# Access Compliance Report

## Public Rights-of-Way

Intersection ID: 2838	Main Street: FOGGY_MEADOW_RD	Cross Street: LONG_FOREST_DR	Location: SE
ADA ID: 18C8BF62017B	Ramp Type: Perp	Initial Pass/Fail: Fail	Overall Compliance: No
Severity Score: 13.75			
Codes/Mitigation Info/Possible Solution		Field Measurements/Component Compliance

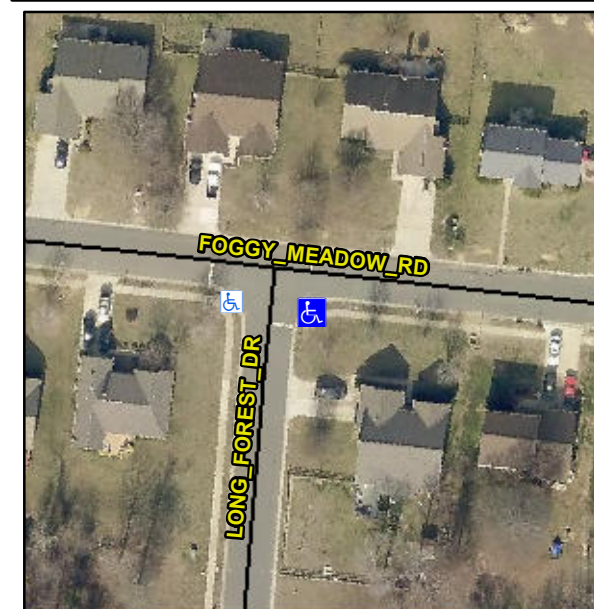
**Remove & Replace Entire Ramp.**

**Not Found, R304.2.2, R304.5.3**

Compliance	Description	Data	Compliance	Description	Data
N/A	Ramp Length (in)	47.0	No	Ramp Slope (%)	10.7
Yes	Ramp Width (in)	48.0	No	Ramp XSlope (%)	4.7
N/A	Flare Type LT	N/A	N/A	Flare Type RT	N/A
N/A	Flare Slope LT (%)	N/A	N/A	Flare Slope RT (%)	N/A
N/A	Flare Traversable LT?	N/A	N/A	Flare Traversable RT?	N/A
N/A	Landing Length (in)	N/A	N/A	DWS Provided?	N/A
N/A	Landing Width (in)	N/A	N/A	DWS Contrast?	N/A
N/A	Landing Slope (%)	N/A	N/A	DWS Length (in)	N/A
N/A	Landing X Slope (%)	N/A	N/A	DWS Full Width?	N/A
N/A	Landing Curb? (Y/N)	N/A	N/A	DWS Offset (in)	N/A
N/A	Shared Landing?	N/A			
N/A	Gutter Ponding?	N/A	N/A	Gutter Slope (%)	N/A
N/A	Gutter Lip Ht (in)	N/A	N/A	Gutter X Slope (%)	N/A
N/A	Painted X Walk1?	No	N/A	Painted X Walk2?	N/A
	X Walk 1 Direction	To W		X Walk 2 Direction	N/A
N/A	X Walk 1 Width (in)	N/A	N/A	X Walk 2 Width (in)	N/A
	X Walk 1 Slope (%)	4.9		X Walk 2 Slope (%)	N/A
	X Walk 1 X Slope (%)	3.8		X Walk 2 X Slope (%)	N/A
